Re: Docket ID NRC-2011-0148: Scoping Comments For Proposed Expansion Of  
Ross In Situ Uranium Recovery (ISR) Project To Include The Kendrick  
Expansion Area (License SUA-1601)

Re: Draft Environmental Impact Statement  
Ross In-Situ Uranium Recovery Project,  
CEQ#: 20130073

**SECOND DECLARATION OF CHRISTOPHER E. PAINE IN SUPPORT OF THE  
NATURAL RESOURCES DEFENSE COUNCIL & POWDER RIVER BASIN  
RESOURCE COUNCIL’S JOINT MOTION TO MIGRATE OR AMEND  
CONTENTIONS, AND TO ADMIT NEW CONTENTIONS IN RESPONSE TO THE  
FINAL SUPPLEMENTAL ENVIRONMENTAL IMPACT STATEMENT**

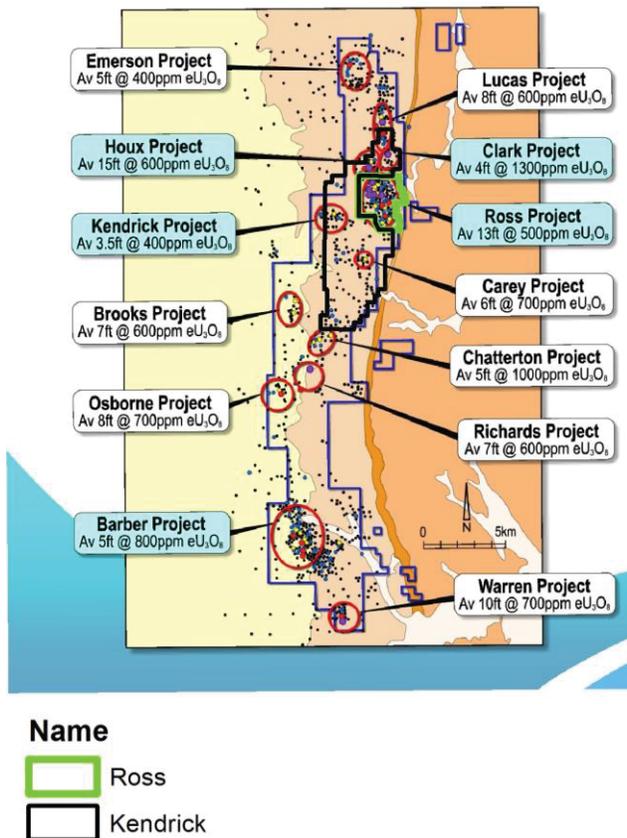
As the Organizations explained in challenging the segmented scope of the Ross Project SEIS, the Commission was required by NEPA and implementing regulations to prepare a single, comprehensive EIS that considers the environmental impacts of SEI’s plans for ISL mining throughout the Lance District, including not only the initial Ross Project and the Kendrick Expansion, but also Richards and Barber areas. Indeed, it has long been evident from Peninsula Energy public documents and statements that SEI will inevitably be developing *all* of these areas. *See, e.g.* Figure 1 below.

All of the projects depicted in Figure 1 are reasonably foreseeable and have been proposed by SEI as expansions of its original Ross Project. They are adjacent to each other in geography and connected via a central processing facility. They are also connected via watersheds, aquifer systems, mineral-bearing formations, ingress and egress roads, and any number of areas whose connection directly bears on the full scope of the impacts.

Figure 1: Lance Projects Pre-Production Drilling Location

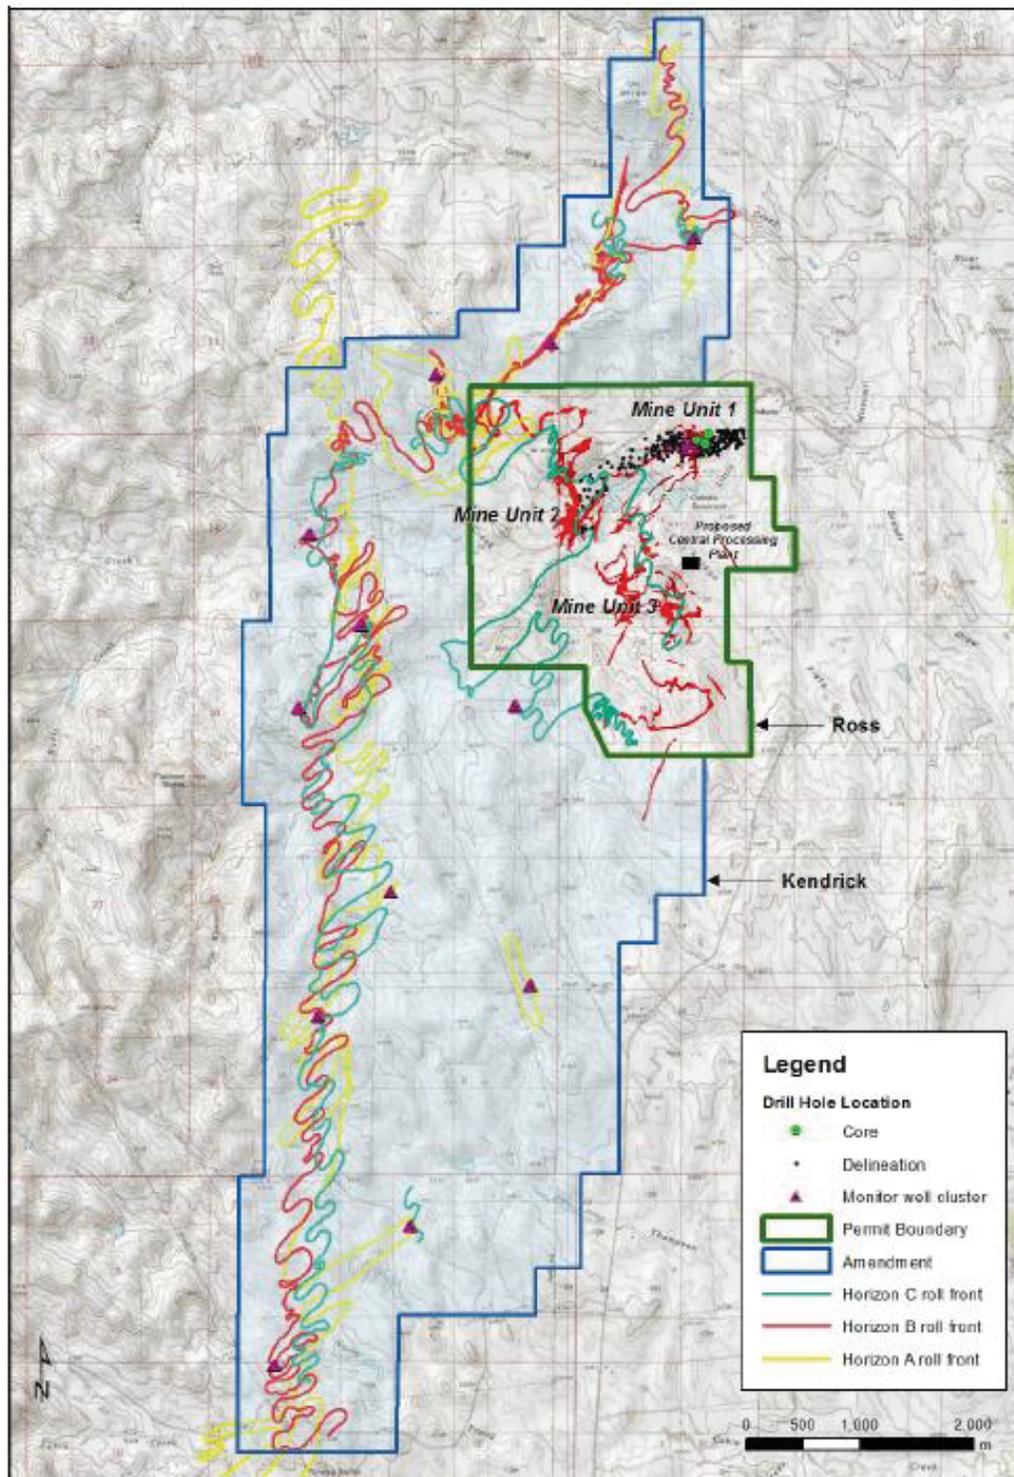
27. As shown in “Figure 1: Lance Projects Pre-Production Drilling Location” on the next page, the Kendrick “Amendment” Area (in light blue) surrounds the Ross “Permit” Area (green border) on three sides and dwarfs it in size, but it is not included within the scope of the FSEIS “Proposed Action.” (Source of figure is the same release cited in 26 above)
